Memorandum Department of Planning

RE: P.Z. 08-2022 TSG Chesterfield Airport Road (Stock & Associates Consulting Engineers Inc.): A request for a zoning map amendment from a "PC" Planned Commercial District to a new "PC" Planned Commercial District for 13 acres located north of Chesterfield Airport Road.

Planning Commission Vote Report

Description: P.Z. 08-2022 TSG Chesterfield Airport Road (Stock & Associates Consulting Engineers Inc.): A request for a zoning map amendment from a "PC" Planned Commercial District to a new "PC" Planned Commercial District for 13 acres located north of Chesterfield Airport Road.

| SHEET NO.: | C1.0 | | |

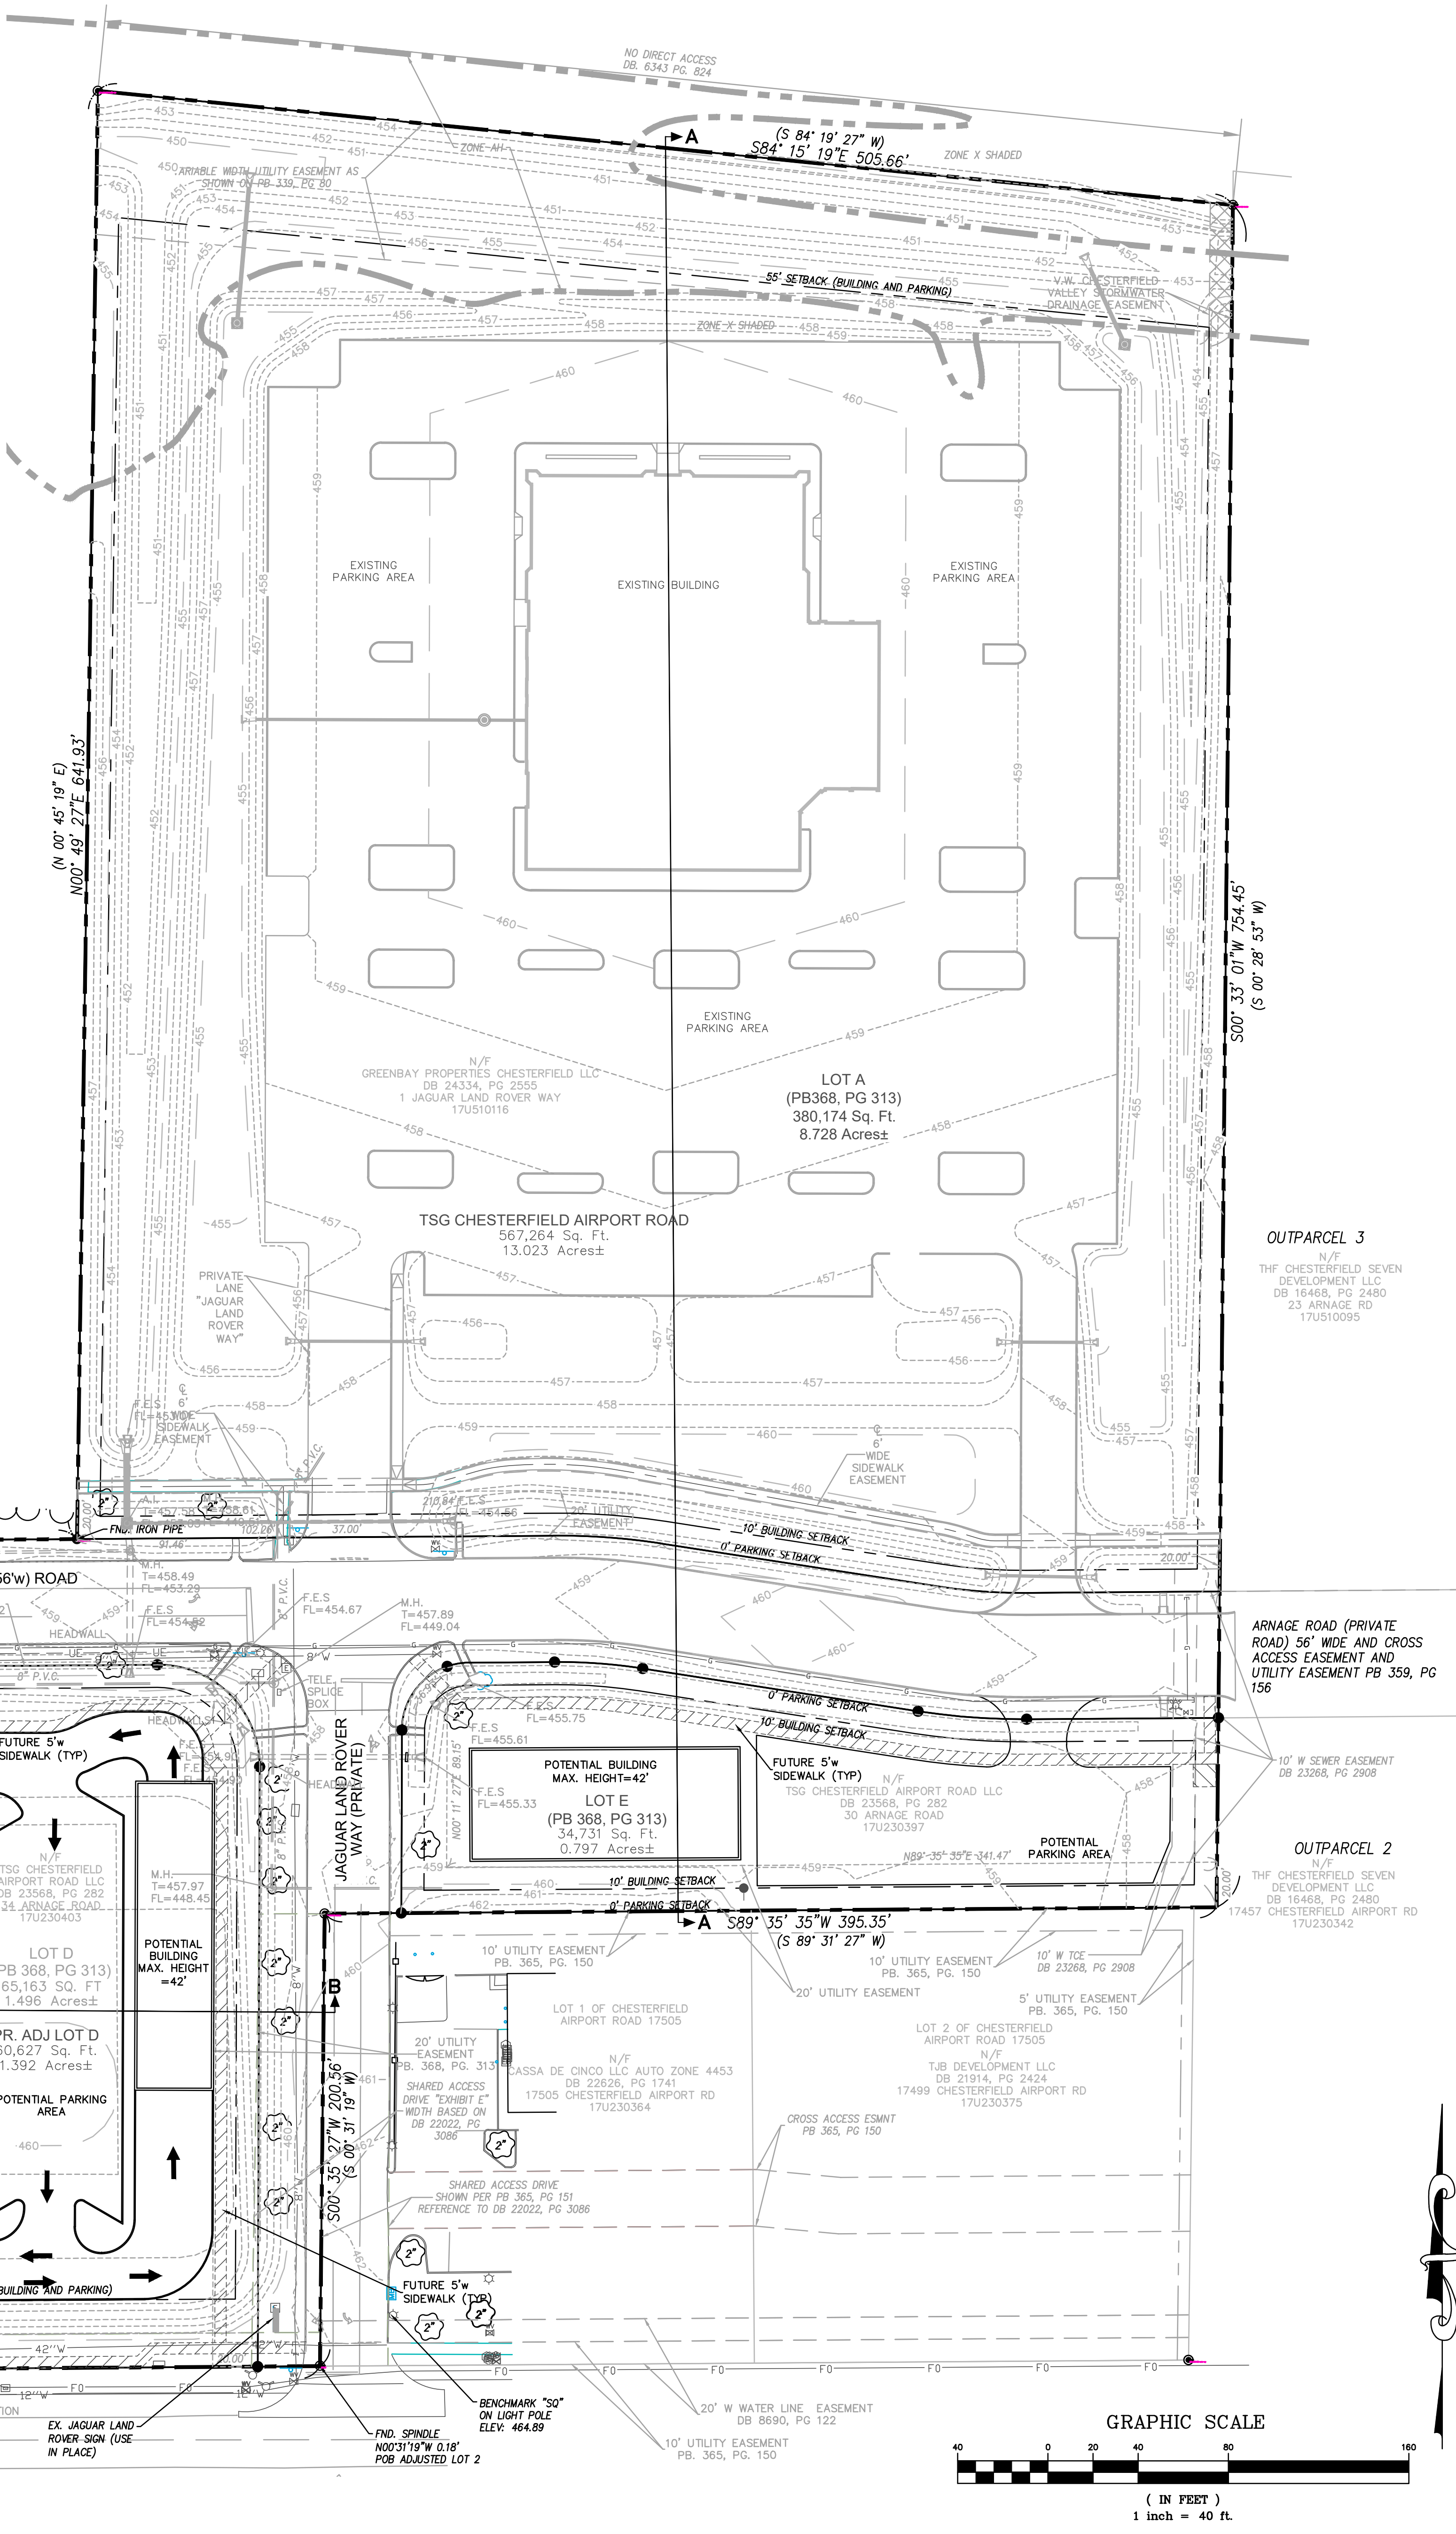
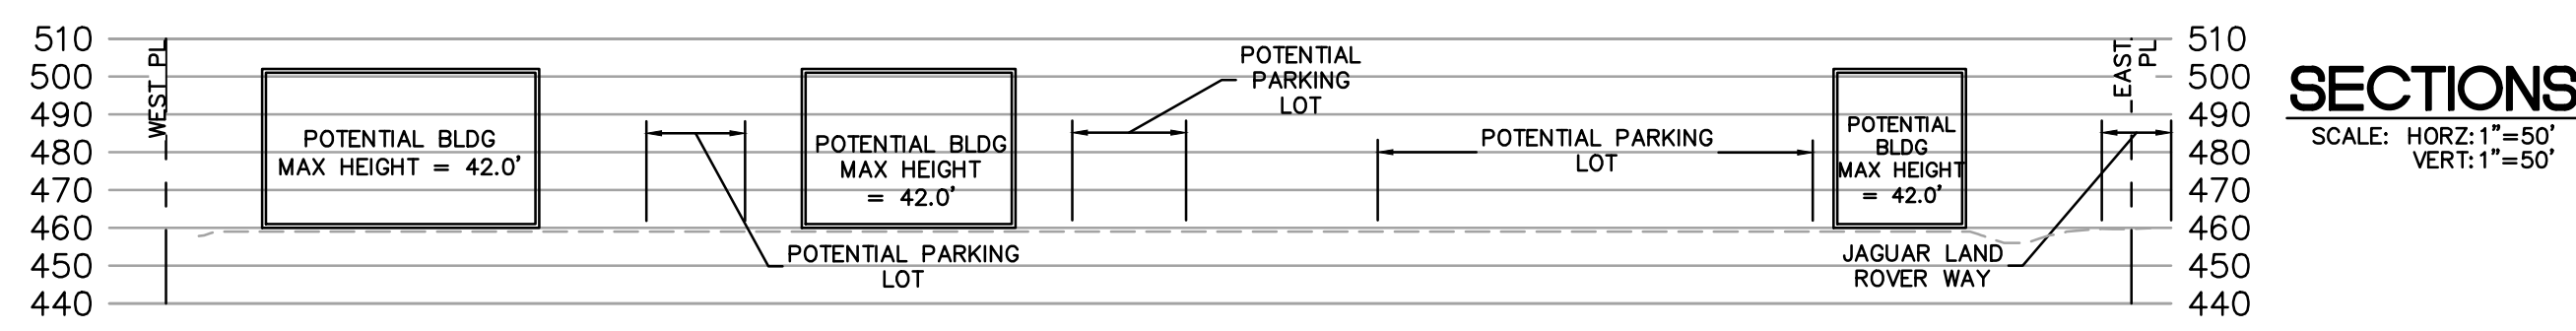
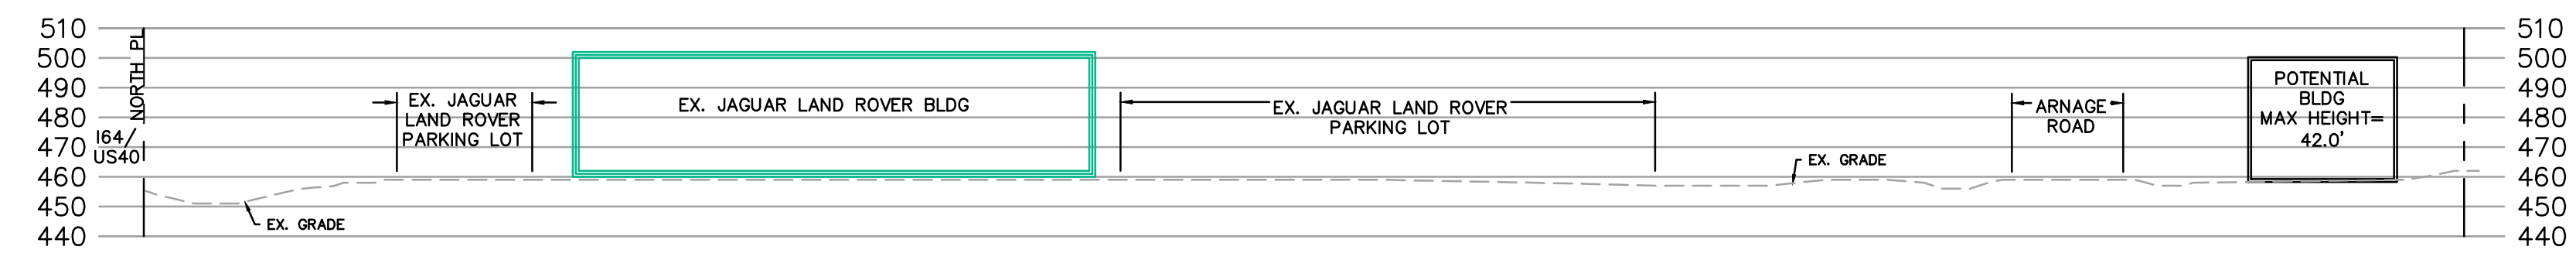
PRELIMINARY DEVELOPMENT PLAN:

Response: Sidewalk added to the Preliminary Plan.
